Item Name: Baggage Compartment Protector Wall

DART SERVICE INSTRUCTION

TO AMEND INSTALLATION INSTRUCTIONS IIN-D407-781-2 REV. A OR LATER APPROVED REVISION
AND INSTRUCTIONS FOR CONTINUED AIRWORTHINESS ICA-D407-781 REV. 3 OR LATER REVISION

A	NEW ISSUE		13.04.08
REV.	DESCRIPTION	BY	DATE
DESIGN		DART AEROSPACE LTD HAWKESBURY, ONTARIO, CANADA	
DRAWN			
CHECKED		DRAWING NO.	REV. A
MFG. APPR.	N/A	DSI 9649	SHEET 1 OF 2
APPROVED		TITLE	SCALE
DE APPR.		ALTERNATE INSTALL	NTS
DATE	13.04.08	COPYRIGHT © 2013 BY DART AEROSPACE LTD. THIS DOCUMENT IS PRIVATE AND CONFIDENTIAL AND IS SUPPLIED ON THE EXPRESS CONDITION THAT IT IS NOT TO BE USED FOR ANY PURPOSE OR COPIED OR COMMUNICATED TO ANY OTHER PERSON WITHOUT WRITTEN PERMISSION FROM DART AEROSPACE LTD.

**FIGURE 1 - D3879-1 BAGGAGE COMPARTMENT WALL
PROTECTOR - ALTERNATE INSTALLATION**

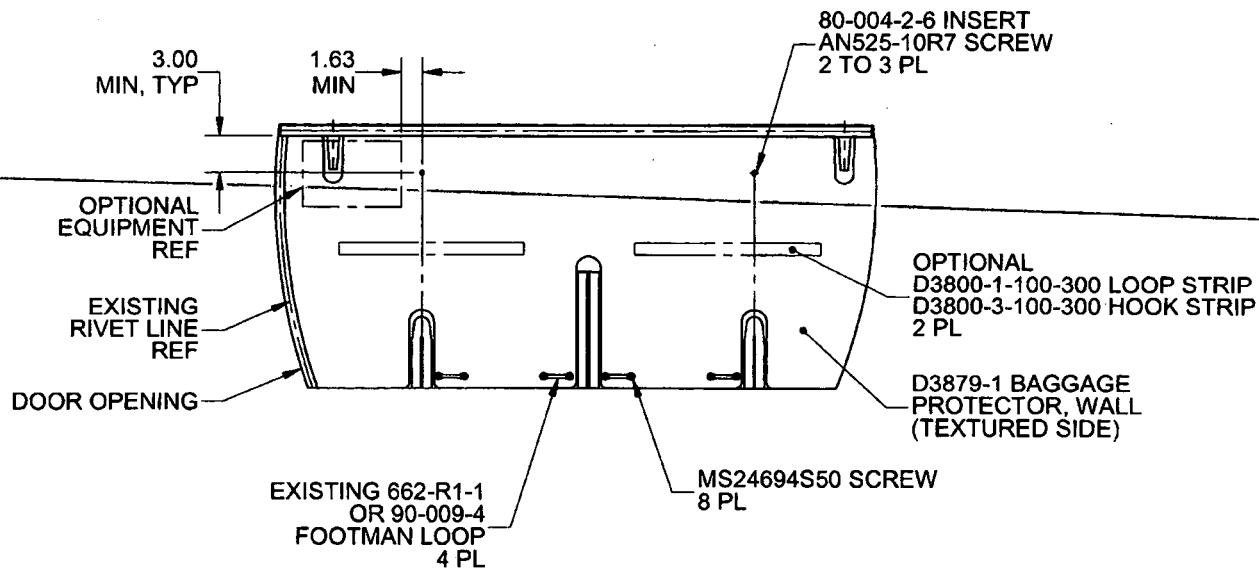
In some aircraft, the top portion of the D206-781-041 Baggage Compartment Wall Protector Kit cannot be installed as indicated in IIN-D407-781-2. The purpose of this DSI is to provide an alternate mounting method to fasten the top portion of the D206-781-041 Baggage Compartment Wall Protector Kit.

It is acceptable to replace qty(2) D3930-1 Clips with qty(2) 80-004-2-6 Inserts. Locate and mark location of the two attachment holes on the baggage compartment wall as shown in Figure 1 of this service instruction. Install 80-004-2-6 Inserts at the marked locations in accordance with Section 3-2-12 of BHT-206-SRM-1. It is acceptable to trim the wall protectors to accommodate optional equipment or transfer attachment holes to the wall protector and install the optional equipment on top of the wall protector with longer fasteners.

Amend the D206-781-041 Baggage Compartment Wall Protector Kit parts list as follows:

Qty -061	Qty -031	Qty -041	Part Number	Description
X			D206-781-061	BAGGAGE COMPARTMENT PROTECTOR KIT (FLOOR AND WALL)
1	X		D206-781-031	BAGGAGE COMPARTMENT FLOOR PROTECTOR KIT
1		X	D206-781-041	BAGGAGE COMPARTMENT WALL PROTECTOR KIT
		2	AN525-10R7	SCREW
		2	80-004-2-6	INSERT
